Architectural Review Board

Meeting Minutes

October 9, 2017

Architectural Review Board Staff Report October 9, 2017 Meeting

Source: Front elevation along Market Street from submittal from Market Street Building Design

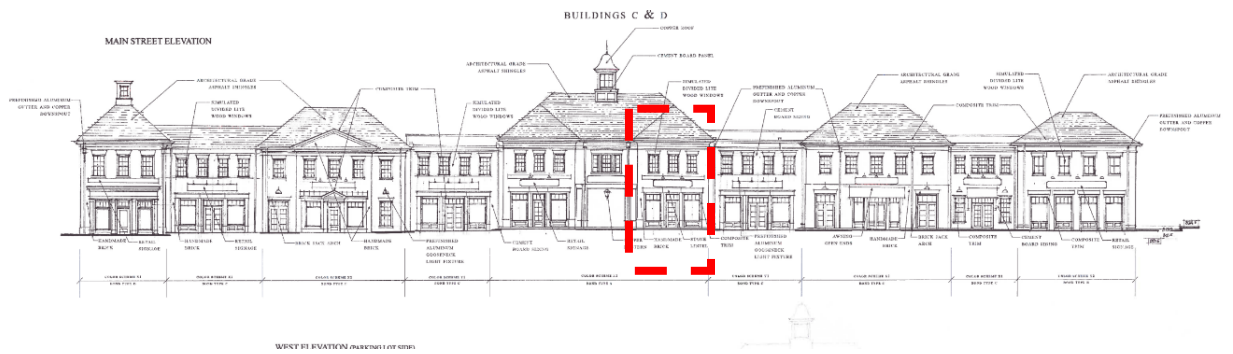
- Board & Brush was approved on the other side of the portal with a sign size of 2' x 14'. Staff recommends that the proposed sign be enlarged to 2' x 14' to match the existing signs.

- The applicant does not indicate if there is going to be two signs one over each entry, or if only one sign on will be installed. The board should confirm with the applicant how many signs are being installed and which elevations the signs will be located on.

1. The sign should be enlarged to be 2' x 14'.
2. There should be two signs, one on the Main Street elevation and one on the parking lot elevation to match the other existing signage in the area.

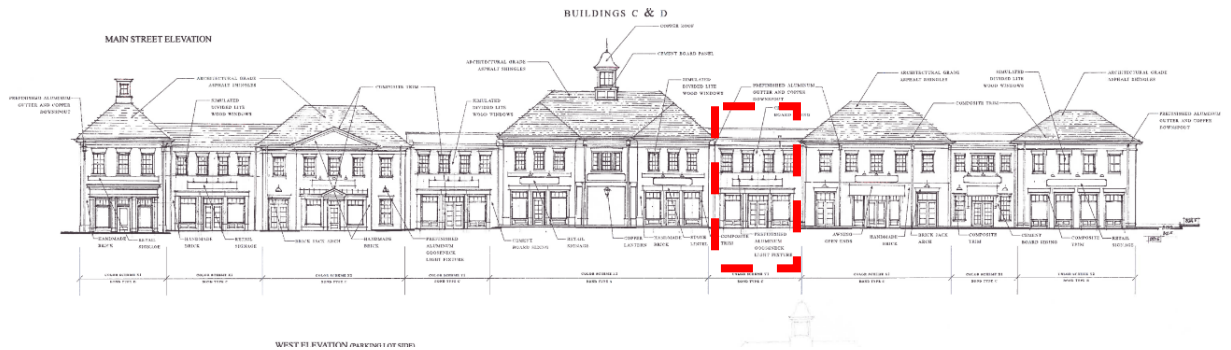
- n. Lettering Height: 14.42 inches [meets code]
- The sign will read "PetPeople."
- The proposed sign has cove-cut edges with scalloped corners.
- One sign is located above the primary entrance to the business on the Main street elevation of the building.

- The second sign is located above the entrance to the business from the parking lot (west) elevation of the building.
- The Architectural Review Board previously approved the Board and Brush sign to be sized 2'x 14' since it is the standard size of a wall sign in the Market Square area and 14' x 2' is appropriately scaled to the building and amount of store frontage area for that tenant space. The Board and Brush tenant consists of 22 feet of store frontage. The application for PetPeople is proposing a sign sized 2'x 14.5" for the East elevation on Main Street which is (slightly) larger but has a store frontage of 32 feet. Staff recommends the Architectural Review Board evaluate the proposed size of the sign in relation to the store frontage and its relation to existing and future signs.

- According to C.O.1169.12(b)(1) Signs do not block portions of architectural detailing, windows, entries, or doorways. The sign's mounting location appears to block architectural detailing on the west elevation. The proposed sign is 2' x 12', which covers a 10' brick detailing. ARB has been approving consistent sized signs but, historically has not approved signs covering architectural detailing. Staff recommends the ARB should evaluate the size of the sign in relation to other signs and the brick detailing for the west elevation.

Staff recommends approval of this application because the proposed sign is consistent with the other signs' dimensions, design, and locations within the Market Square area. The wall sign is an appropriate sign type for this location. Staff recommends the ARB evaluate the appropriateness of the proposed size of the sign in relation to overall Market Square, the amount of tenant space, and the architectural detailing on the west elevation.
